*TL carryover comments
#107,102,99*

from San Antonio

Today's date: 11/23/04

Test drawing for #107

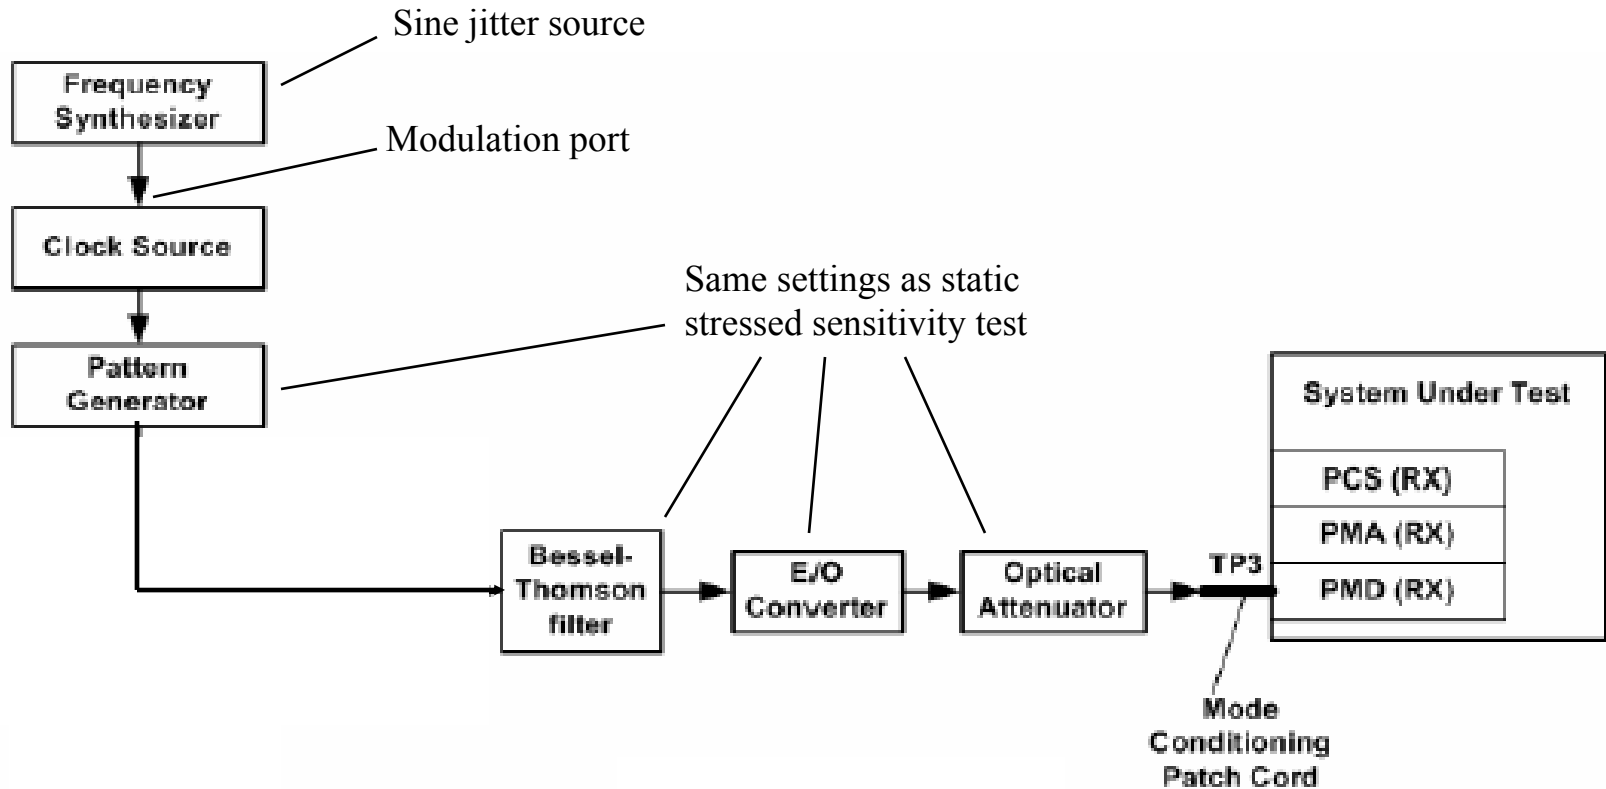
- # 107 Cl 68 SC 6.5 P 11 L
- *Comment Type T*
 - Need a low frequency jitter test.
- *Suggested Remedy*
 - Propose 5 UI at 40 kHz sine jitter test condition. Use current Stressed eye generator figure but remove Gaussian noise and ISI generator. Keep all else as is. Use words for subclause 68.6.5.1 (modified by another comment) to specify requirements about BER, etc. [It's a BER test, not a sensitivity test]
- *Response Status*
 - Withdrawn.
- *Discussion*
 - As a group, I think we agree on this. It was withdrawn for lack of time and because of the “new rules” for commenting. I have included a figure (see next).
- *New suggested remedy*
 - If we agree with the figure, the values, and the BER statement, then I will re-write the comment per the new rules for the next draft.
